**STAFF REPORT**  
**COMMUNITY DEVELOPMENT DEPARTMENT**

SUBJECT: H-2020-0005  
 Landing South – RZ, PP

LOCATION: 660 S. Linder Rd. (Parcel #S1213233965; NW ¼ of Section 13, T.3N., R.1W.)

D. Open Space Exhibit (dated: ~~May 28, 2020~~ October 5, 2020)

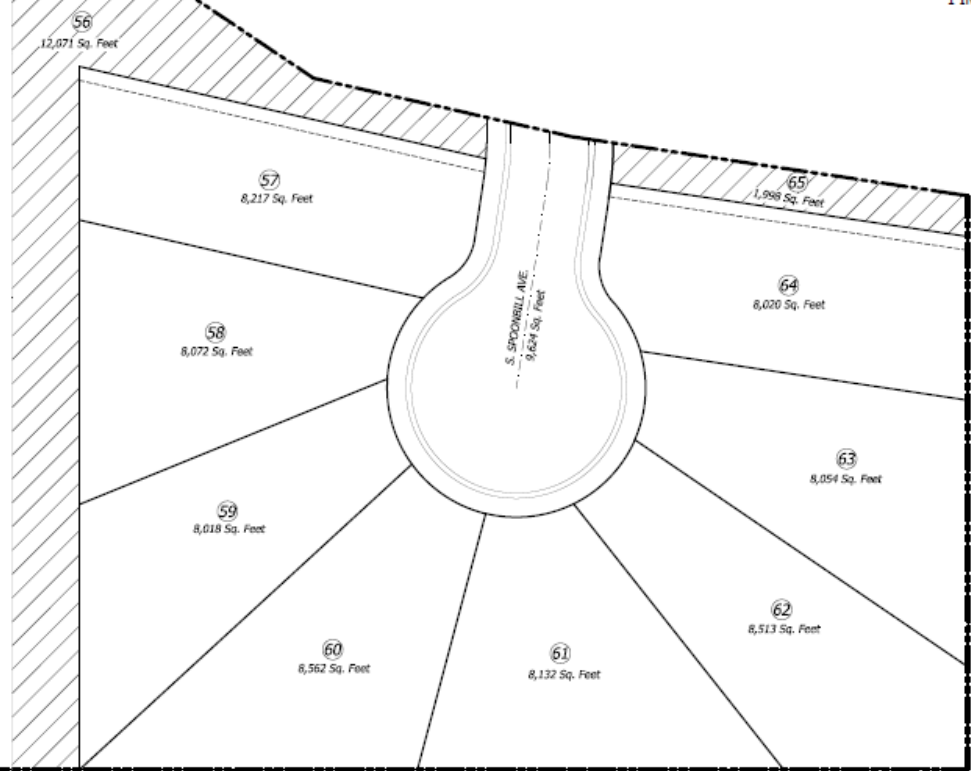
Common open space is required to be landscaped in accord with the standards listed in [UDC 11-3G-3E](#). At a minimum, one three per 8,000 square feet of common area is required to be provided along with lawn. Because the common area along the north boundary of the site where the Kennedy Lateral is located is within an Irrigation District easement, no trees are allowed. Therefore, all of the required trees are proposed to be placed in the street buffer along Linder Rd.

A minimum of 10% *qualified* open space meeting the standards listed in UDC 11-3G-3B is required for developments over 5 acres in size; because this property is only 2.27 acres, this standard does not apply. However, the Applicant did submit an open space exhibit that depicts ~~0.37~~ 0.32 of an acre of common open space including street buffer along Linder Rd. and area along the north boundary of the site where the Kennedy Lateral is located.
